DANE COUNTY DEPARTMENT of PUBLIC WORKS, HIGHWAY and TRANSPORTATION

RFB NO. 314036 - ADDENDUM NO. 2

DINING PLAZA AT THE HENRY VILAS ZOO

COLUMN CAP AT ALTERNATE #1

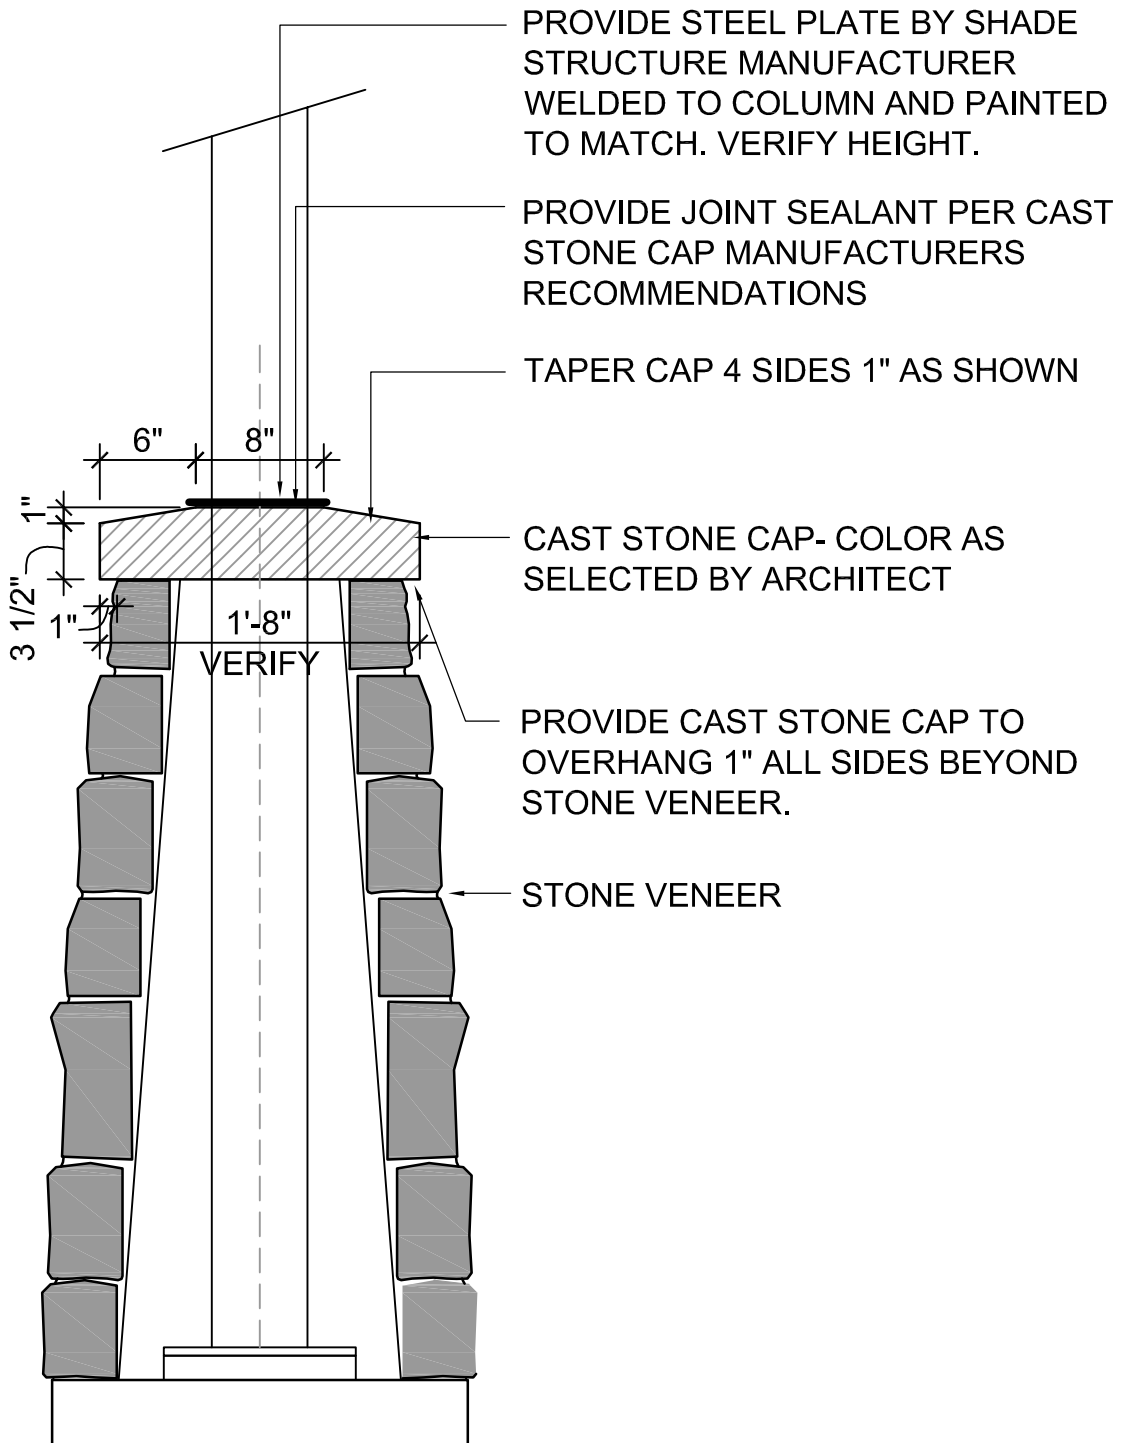
5. Sheet SA2.1

Detail A

Delete current Detail A; replace with SA2.1 Detail A issued with this addendum.
